# Z-86

**ZONING COMMENTS:**

**PLANNING COMMENTS:**

Petition No. Z-18795  
Meeting Date 2/21/10  
Continued Site Plan referenced in letter

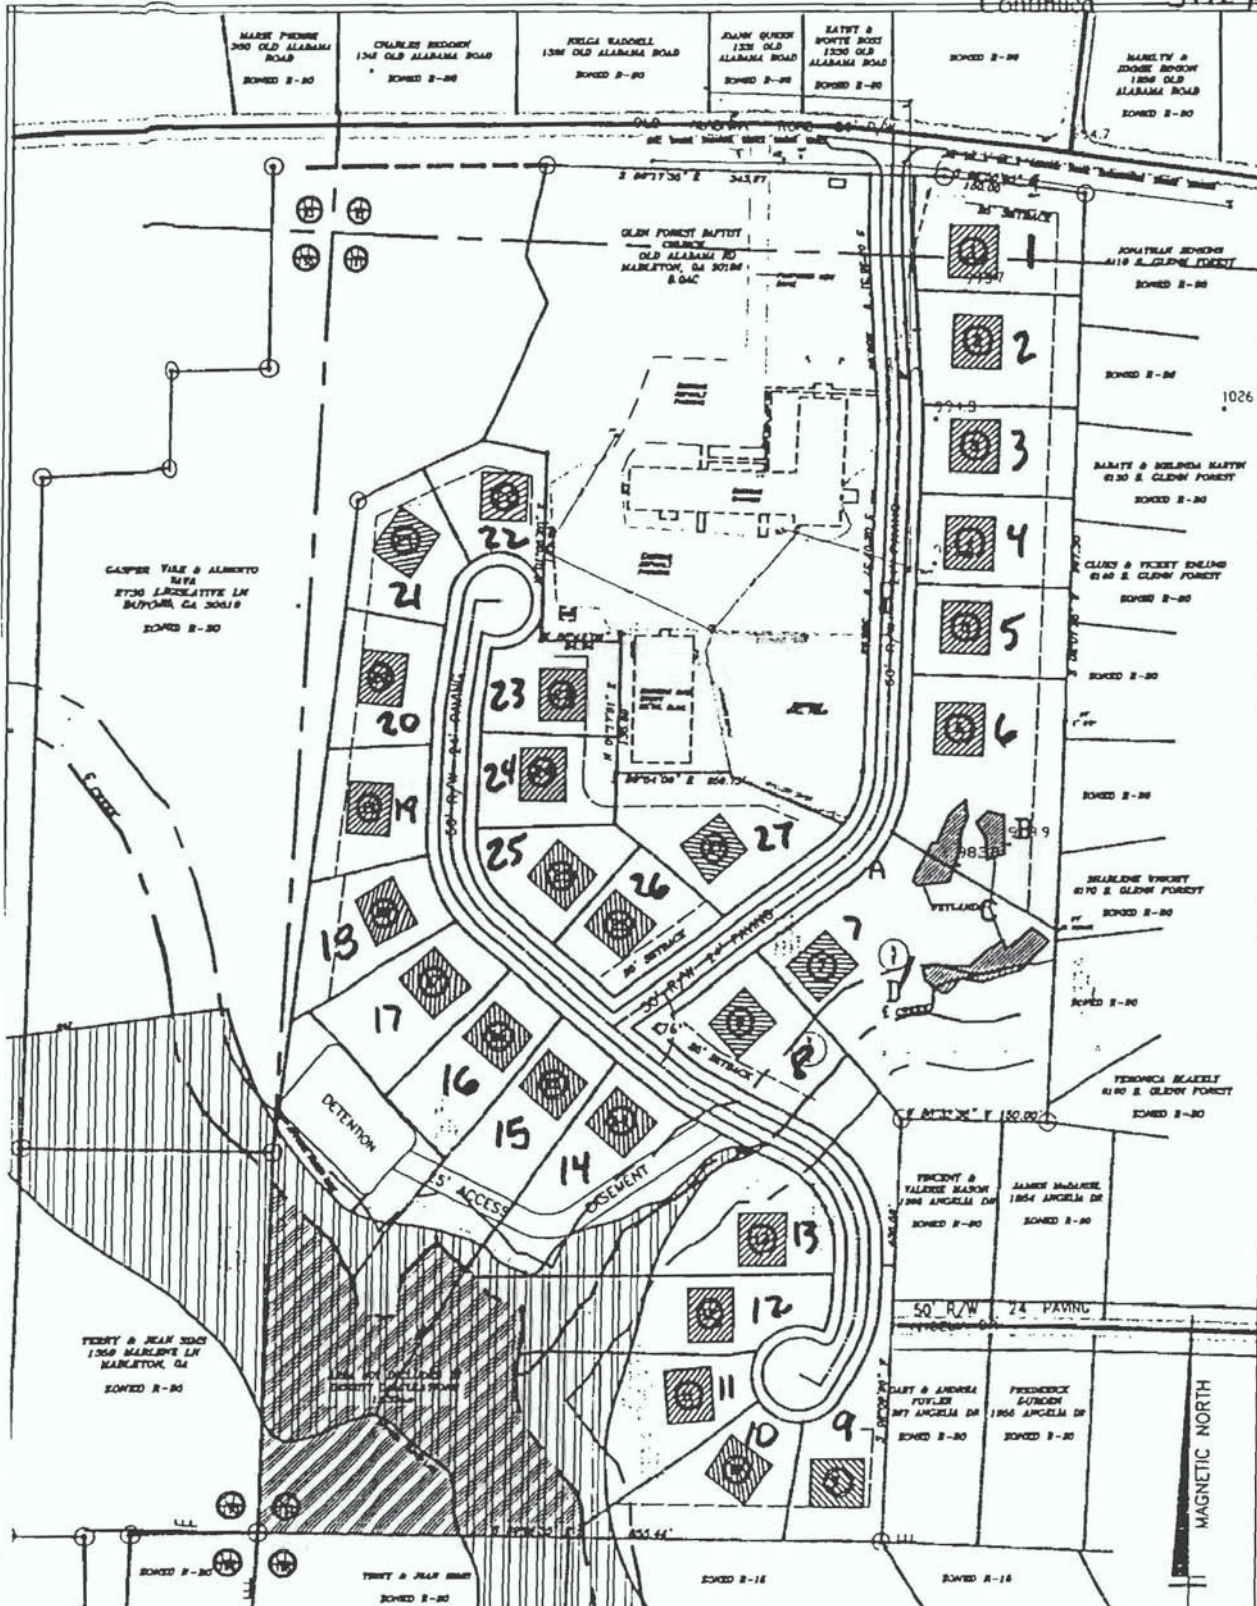
- 8) Revised Plan presented at Staff Zoning Analysis Review of 11-18-05 showing increased density from 6 lots to 8 in northeast and eliminating southwest cul-de-sac with ensuring rearrangement of lots and detention. Lot count has increased from 34 to 37. Detention / Water Quality-Best Management Practice is now without access from public road and has been moved into the Open Space area.

- 8.1) All previously made Drainage Comments remain in force.
  - 8.2) The relocation of the detention / Water Quality-Best Management Practice into an isolated area without public road access renders it unacceptable for Public / County perpetual maintenance. Recommend an operating manual be provided for County Review at Plan Review along with a funding arrangement.

- 8.3) This new plan shows the Open Space area increasing, but, at same time the detention / Water Quality-Best Management Practice located therein encumbering some of the Open Space. Suggest the Open Space calculations be refined to be compatible with plan.

- 8.4) The very small lots running against stream buffers and floodplain offer very little latitude for change in detail design. This must be considered a true conceptual plan subject to change. Therefore, Stormwater Management must reserve full right of review and comment for detail plans at Plan Review.
